STR-6050

SERVICE MANUAL SUPPLEMENT

NO. 1
OCT. '70

Subject: Minor change of Model STR-6050

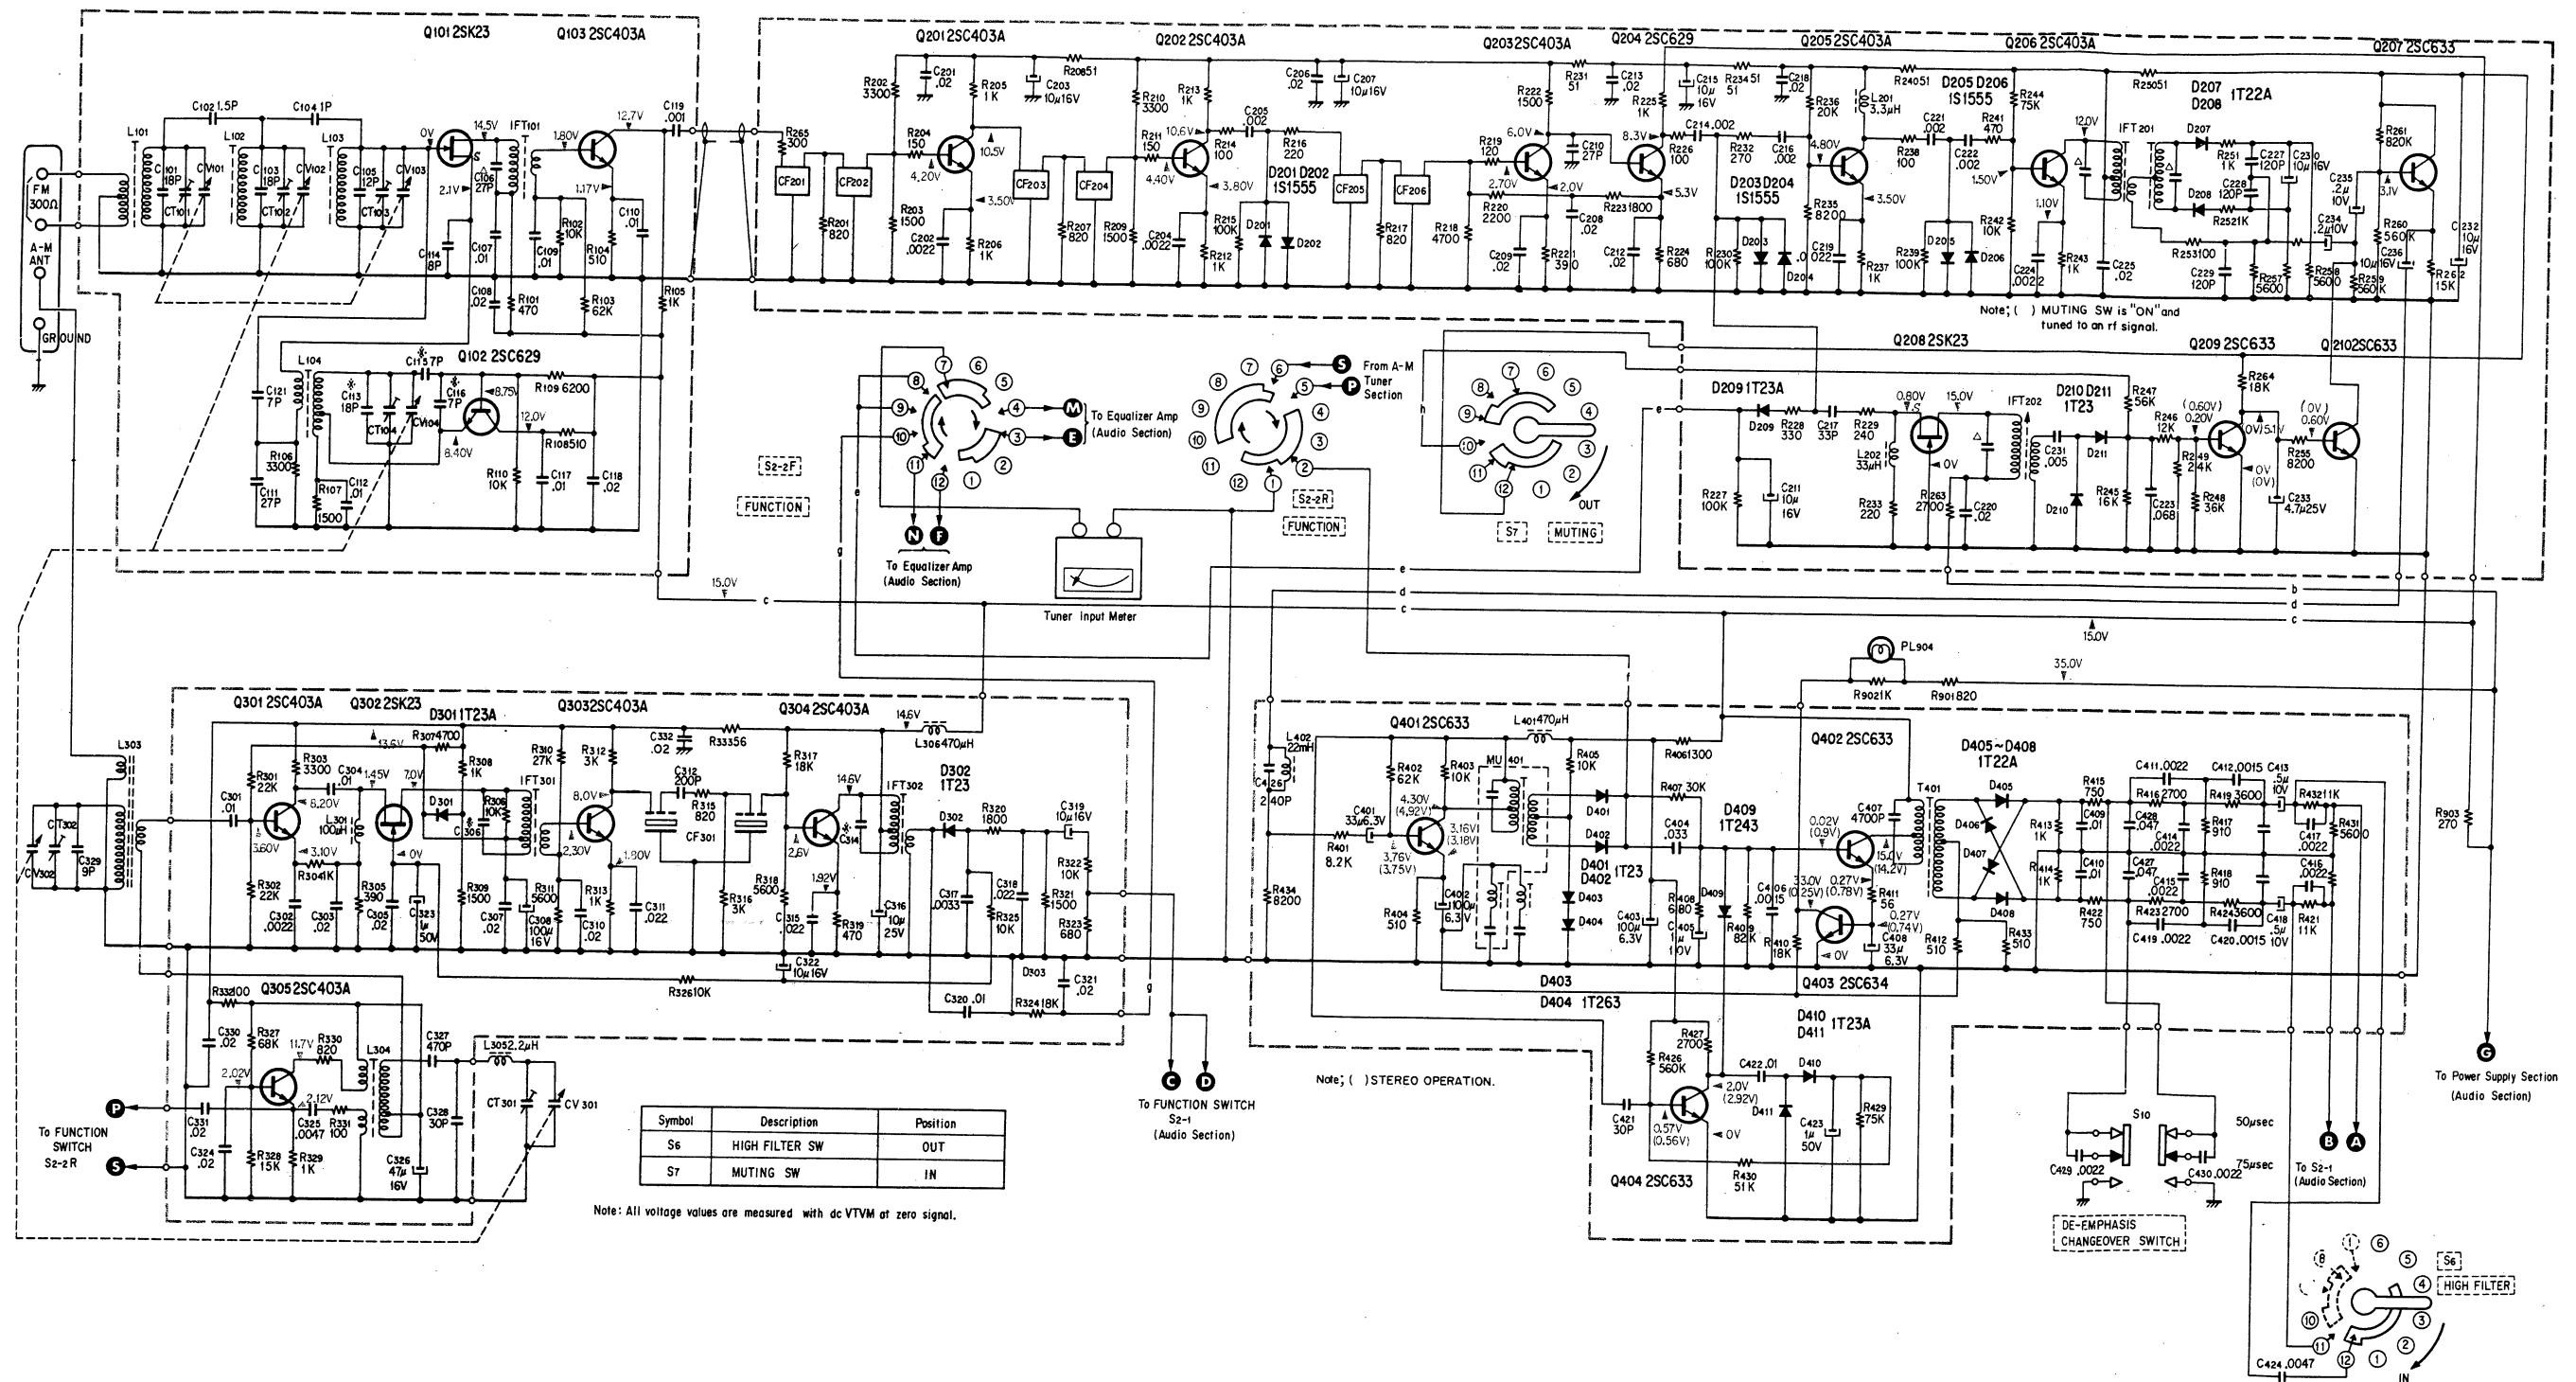
According to the circuit modifications as described herein, reference number of resistor and capacitor in the fm i-f and MPX decoder section has changed. The new schematic diagram is given on pages 5 to 6.

MOUNTING DIAGRAM -MPX and Equalizer Amplifier Board

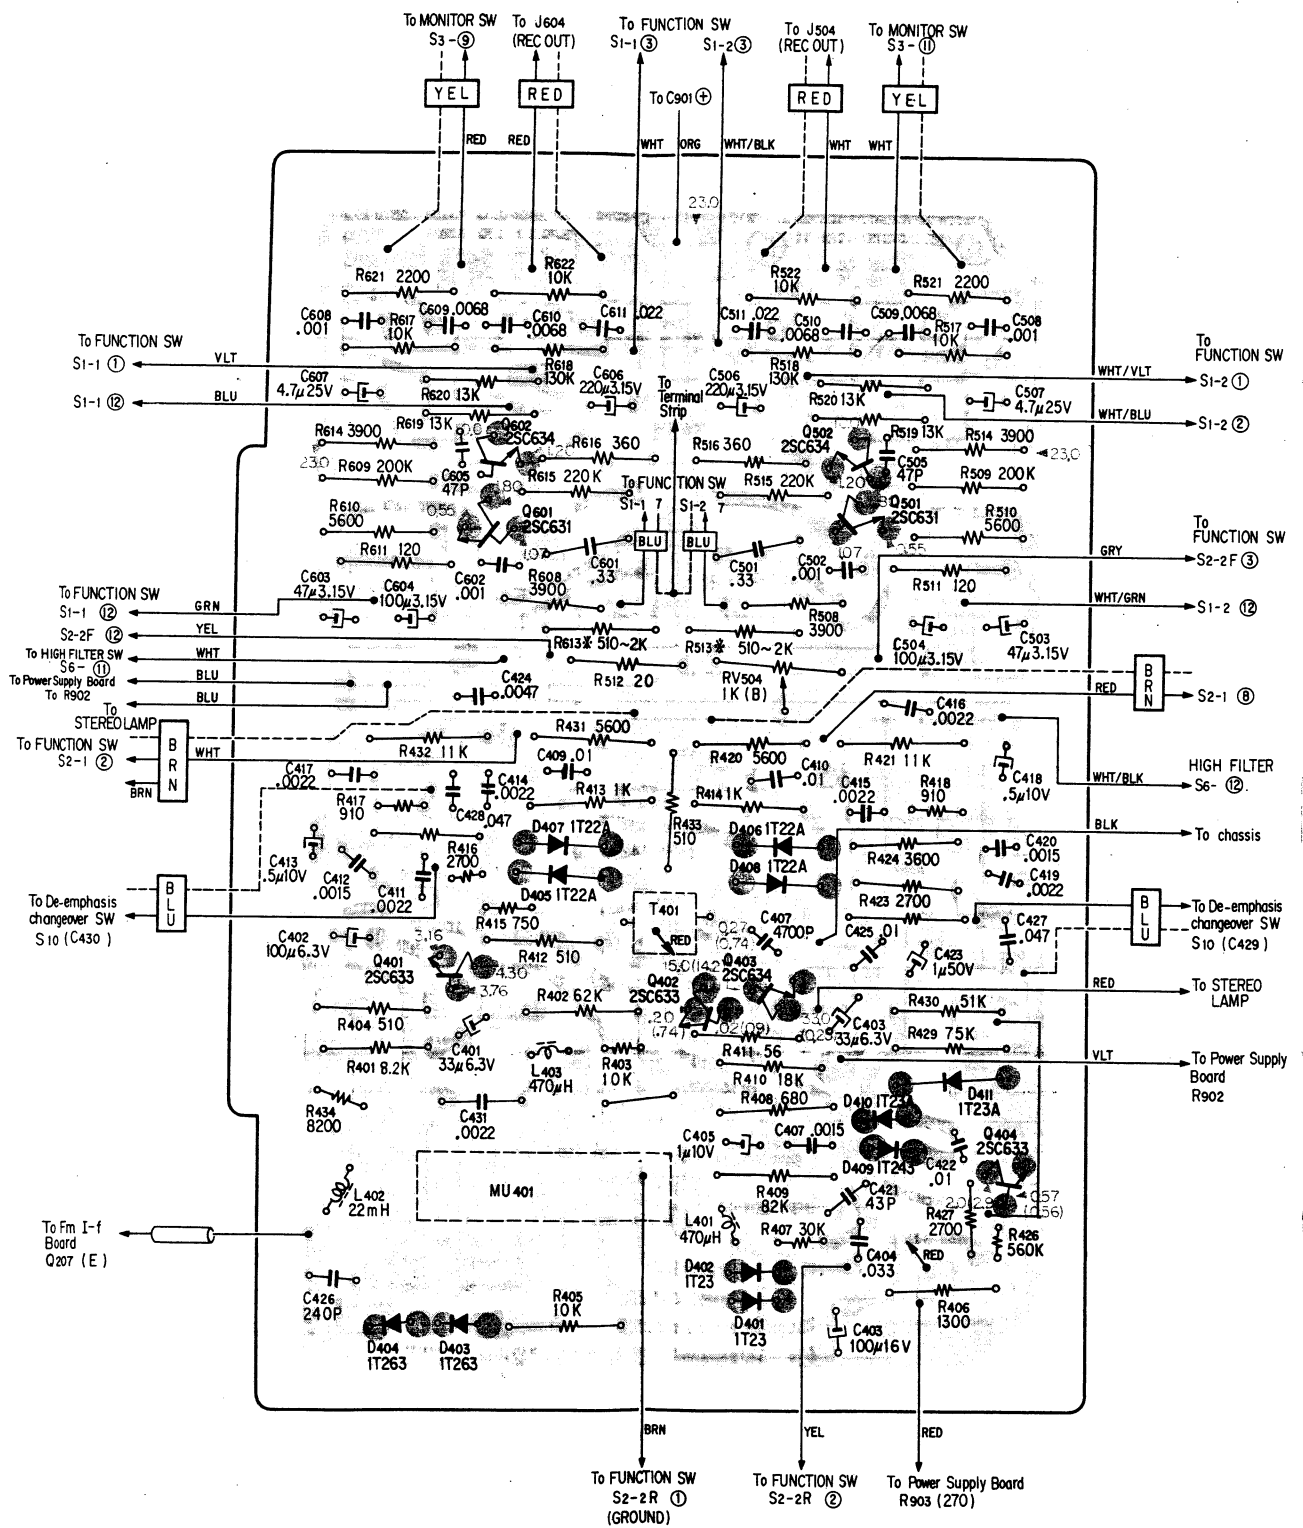
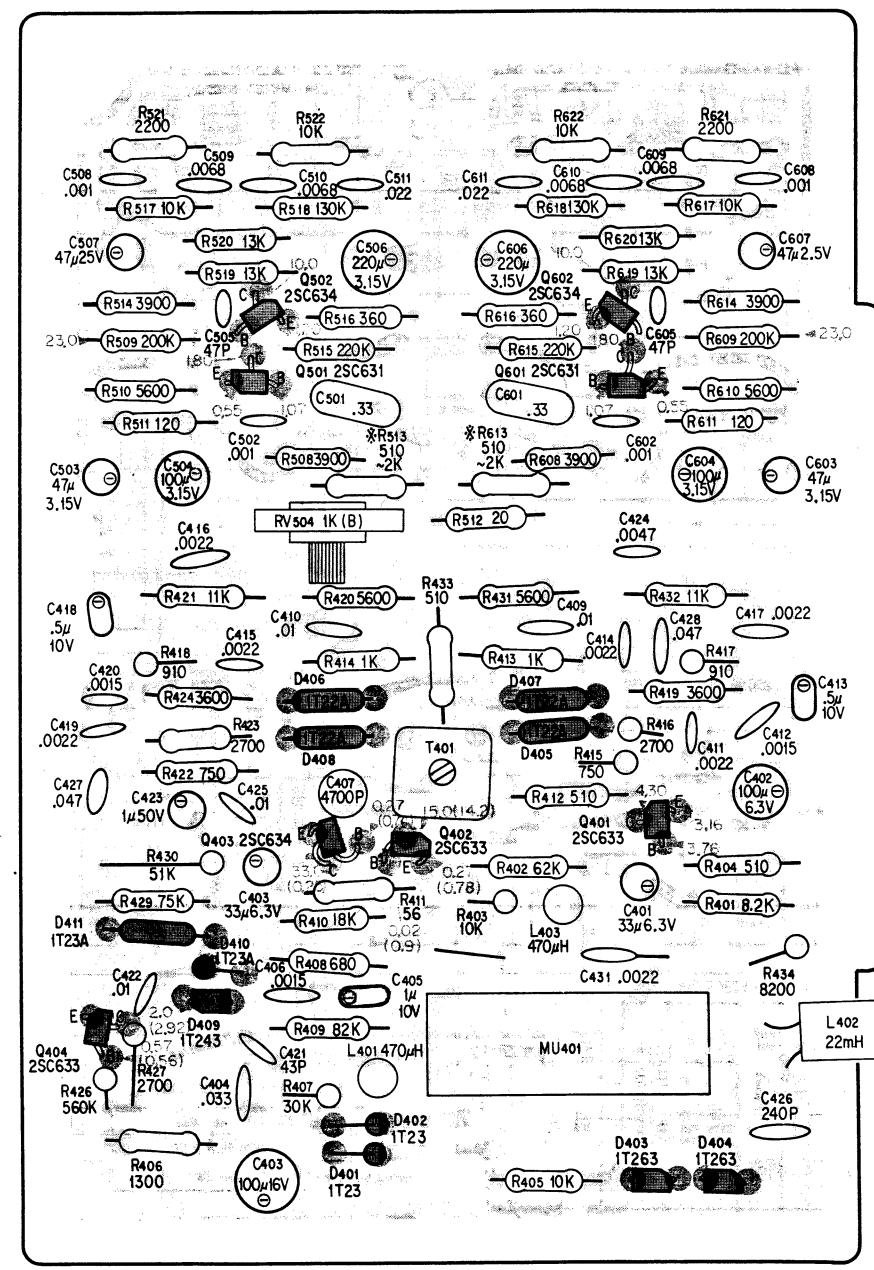
The MPX decoder's printed circuit board has been modified to place the SCA trap circuit on the component side, and some parts have also changed at the same time. New circuit diagram and mounting diagram are given on pages 5 to 8.

<i>Description</i>	<i>Changed to</i>
MPX board. X-20566-25	X-20566-25-3
C421, 62 pF	30 pF (1-101-871), ceramic
L402, 22 mH (1-409-181)	22 mH (1-407-408)

Note: 1. () STEREO OPERATION
 2. R433, C421 and L401 are mounted on conductor side
 * : To be selected
